Municipal Planning & Design Review Commission
Regular Meeting Agenda
Thursday, June 16, 2022, 5:30 PM
City Hall, Lakeland, Tennessee 38002

Project: The Willows at the Lake, Phases 1 and 2 (Lake District Planned Development)
Final Development Plan

RE: The Willows at the Lake Phase 1 (Formerly Phase 9)
Final Development Review Response

THE WILLOWS AT THE LAKE PHASE 1 (SECTION A)

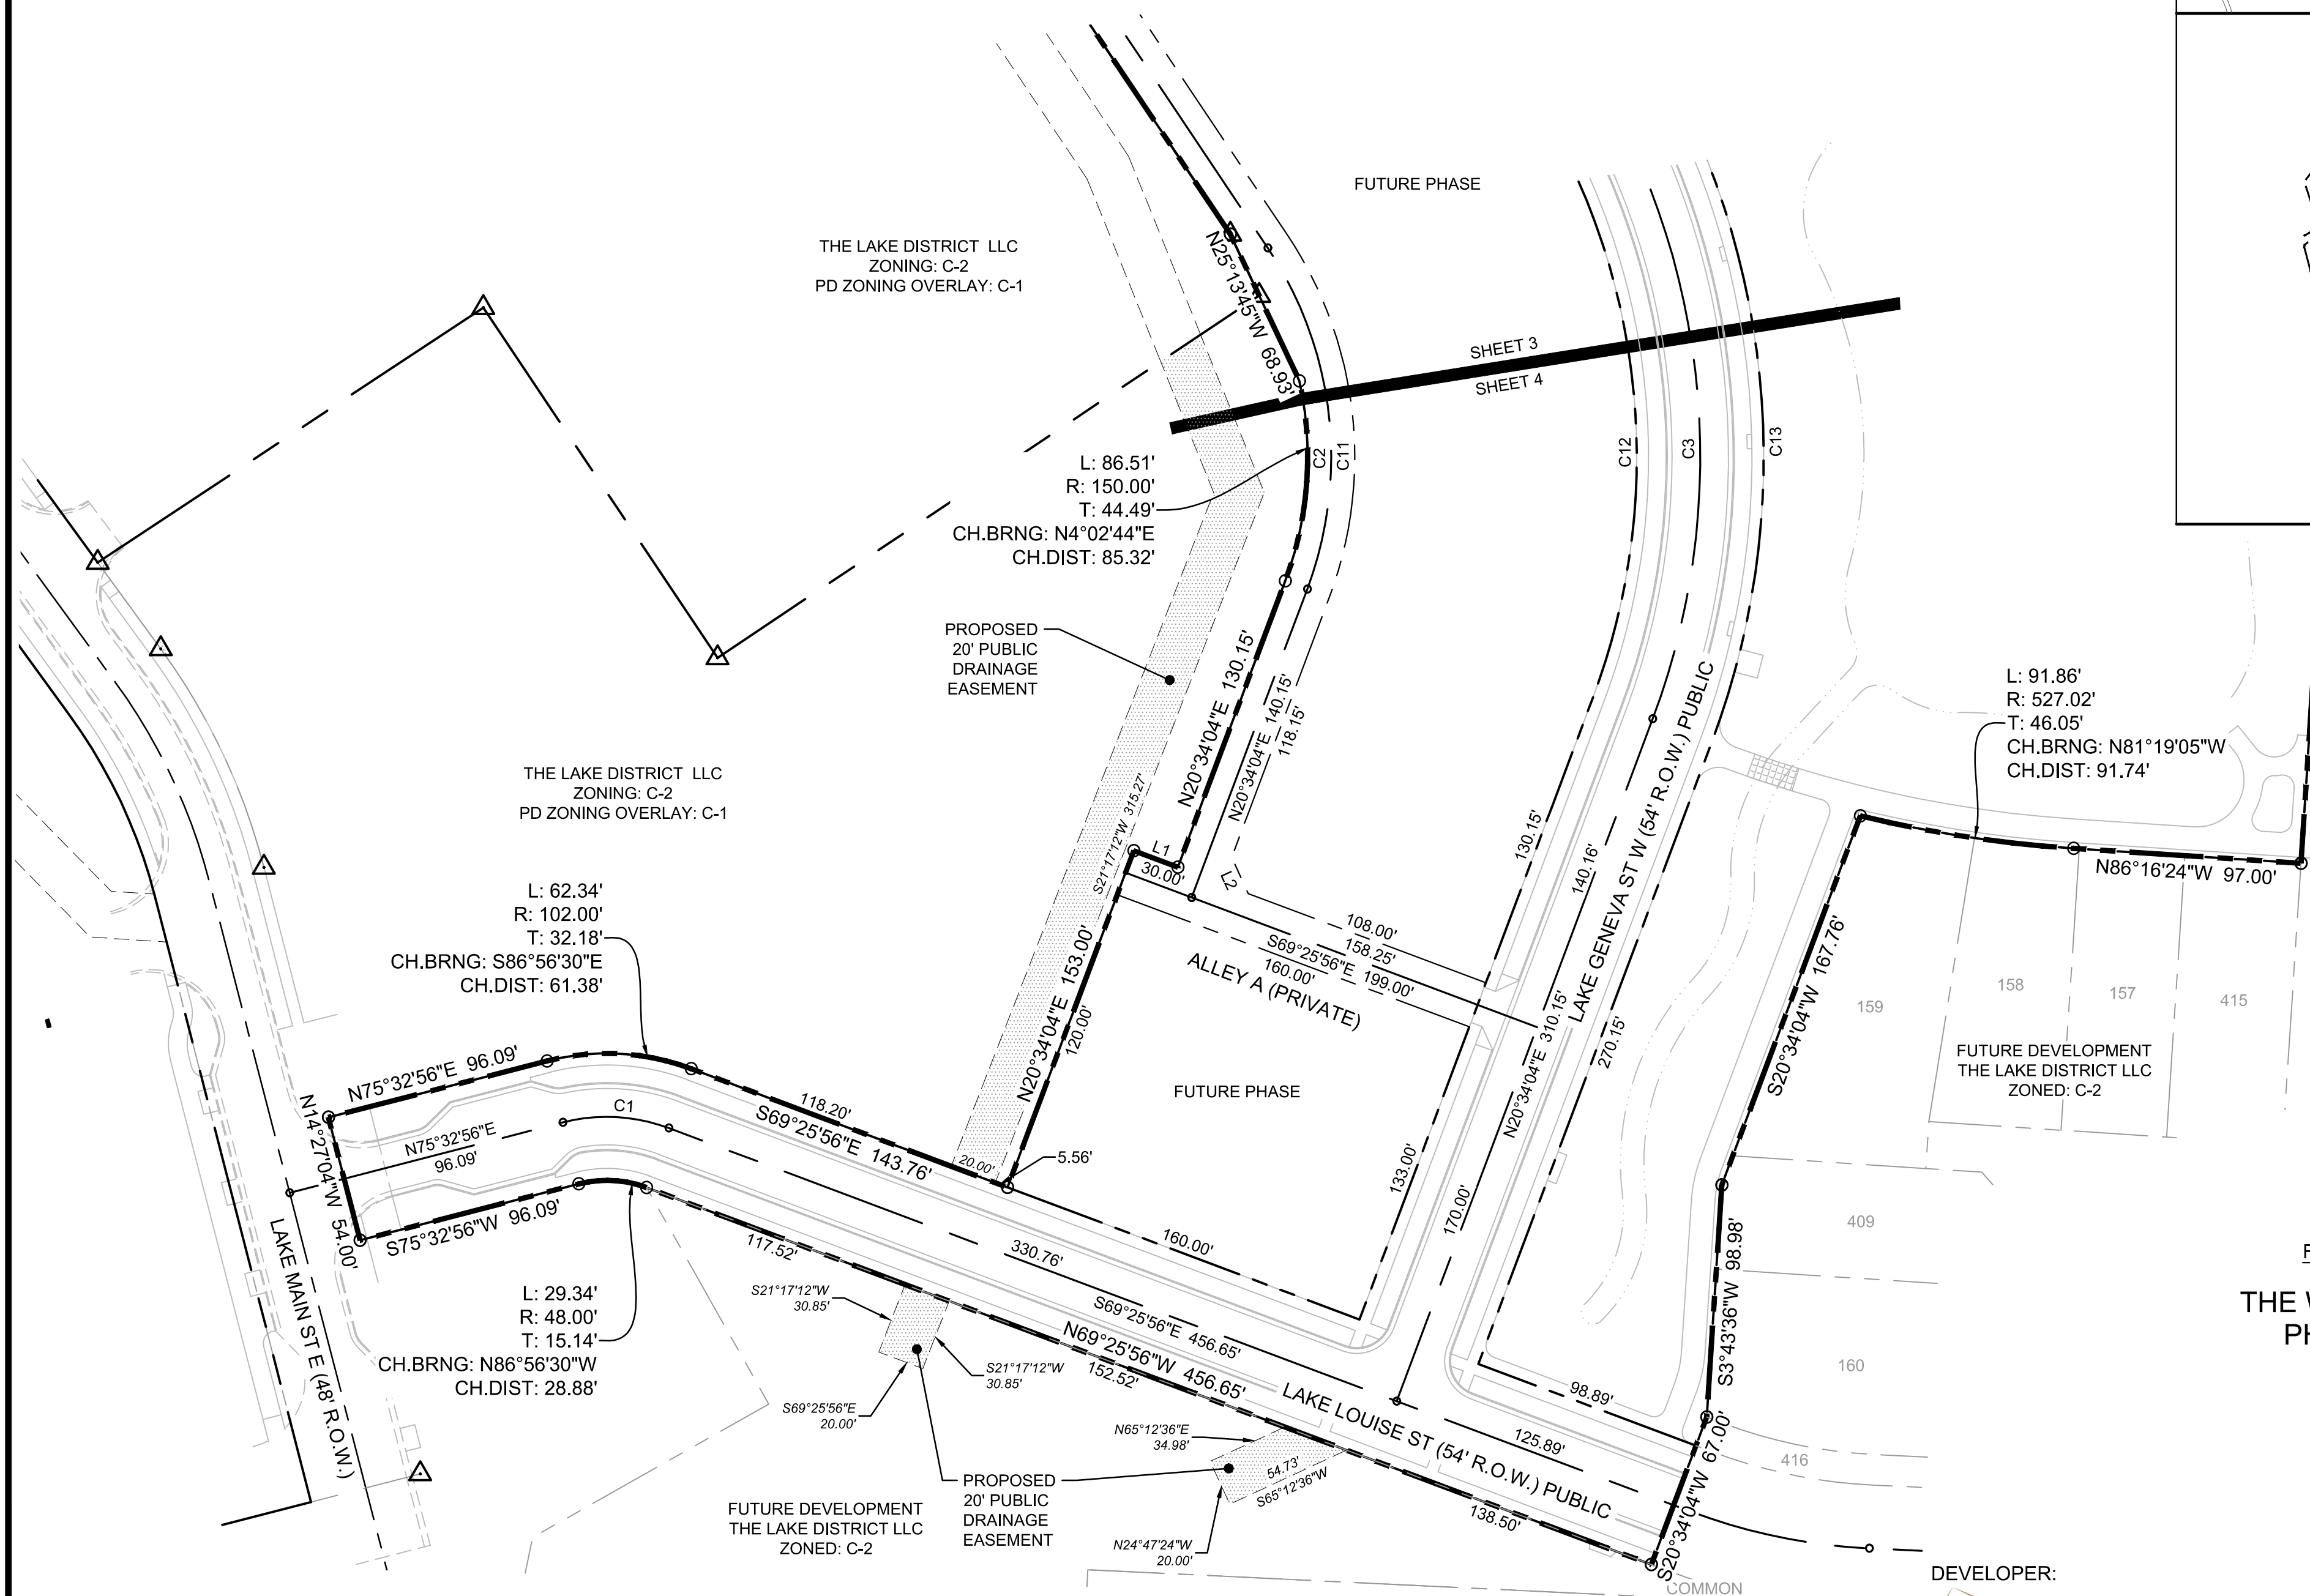
Add notes for COS Maintenance, Scenic Corridor Restriction/Maintenance and Alley Maintenance

Add table of Finish Floor Elevations for each lot.

Add - Property not located in 100 year SFHA and reference FIRM Panel

SEE SHEET 5 of 6 - DDT

SHEET 4 OF 6

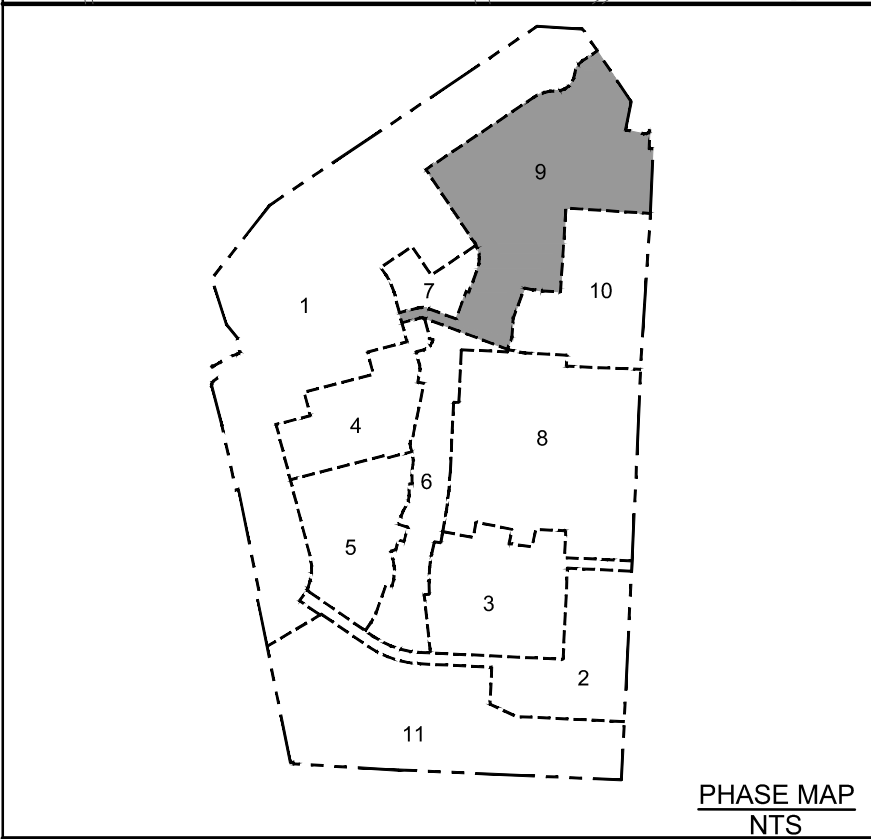
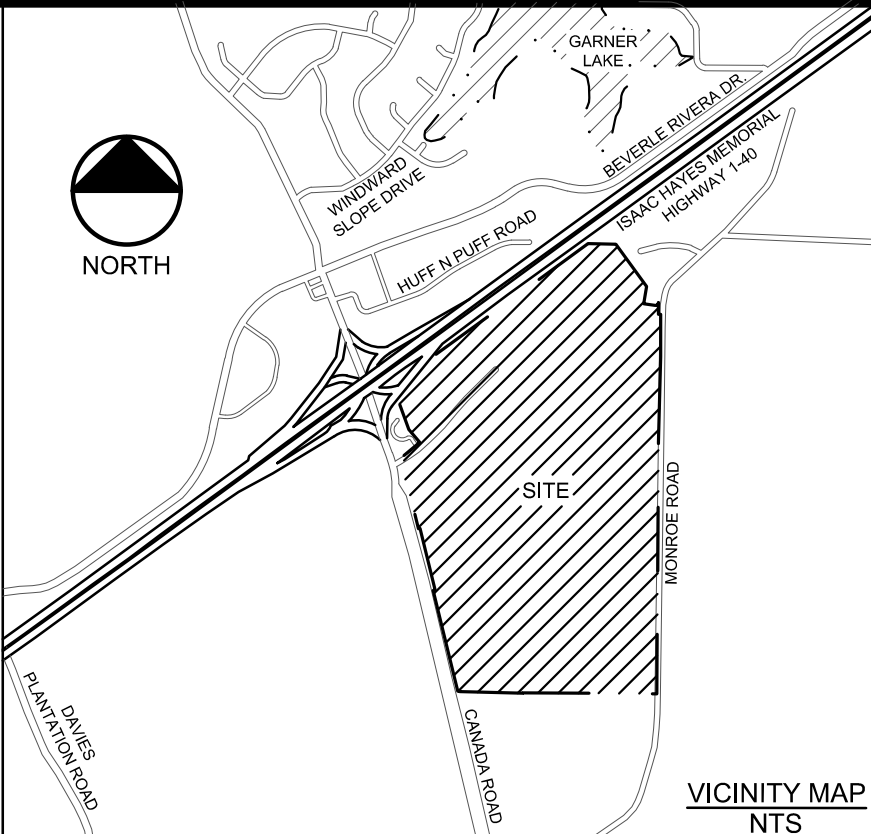
- 5) The scope of the project is unclear based on the sheets included in the initial submittal. Is sheet 4 included because of the drainage easement? Remove this sheet if it is not necessary for this phase. *Sheet shall remain, we are platting all the R.O.W.s and easements in this phase. – DDT*
